Regarding: **Block 1501, Lot 2, Borough of Hillsdale**  
**330 Broadway, Variance Application PZ-01-20**  
**Ilda & Edward Beja, Applicants**  
**NIZA, LLC, Owner**

We are in receipt of a “d1” Use Variance application for the above property to occupy commercial space with a residential unit. Accompanying the application is a Site Plan prepared by Chris Lantelme, PE, LS dated October 30, 2019 entitled “Site Plan for NIZA, LLC, 330 Broadway, Lot 2, Block 1501, Hillsdale, N.J.”

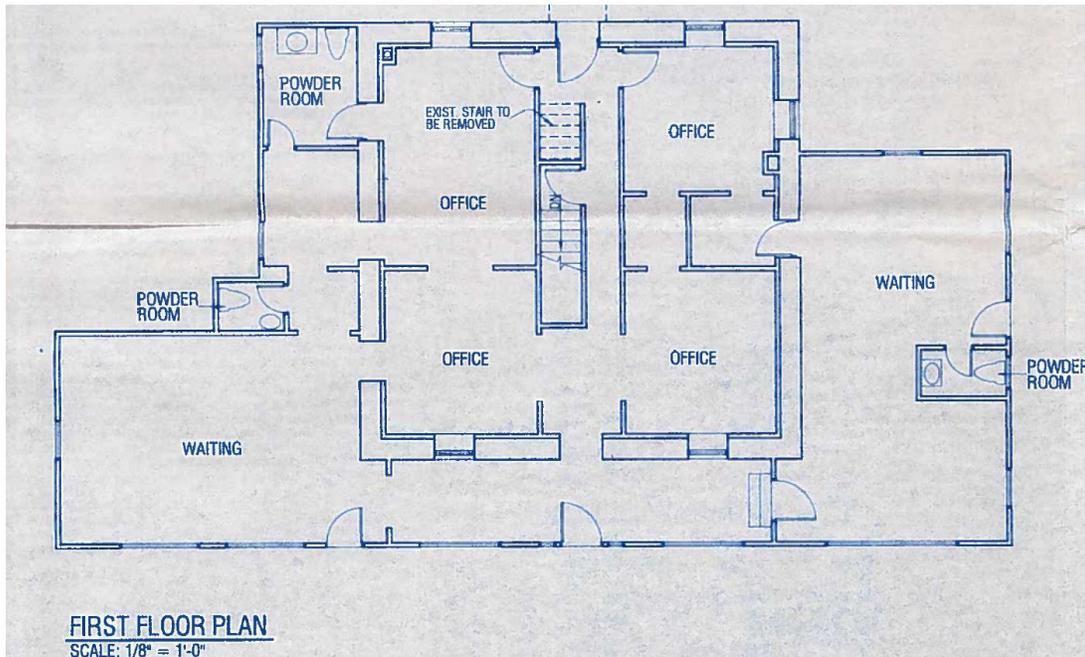
The first floor contains(ed) commercial office space that appears to be used as a physician's office and craft shop (see "First Floor Plan" from prior application).

On the site plan, the applicant proposes to change the use of the northern half of the 1<sup>st</sup> floor to residential use (+/-1,230 SF), thereby having three residential units on the subject commercial property. It appears the southern half of the 1<sup>st</sup> floor (+/-1,130 SF) will remain as commercial use.
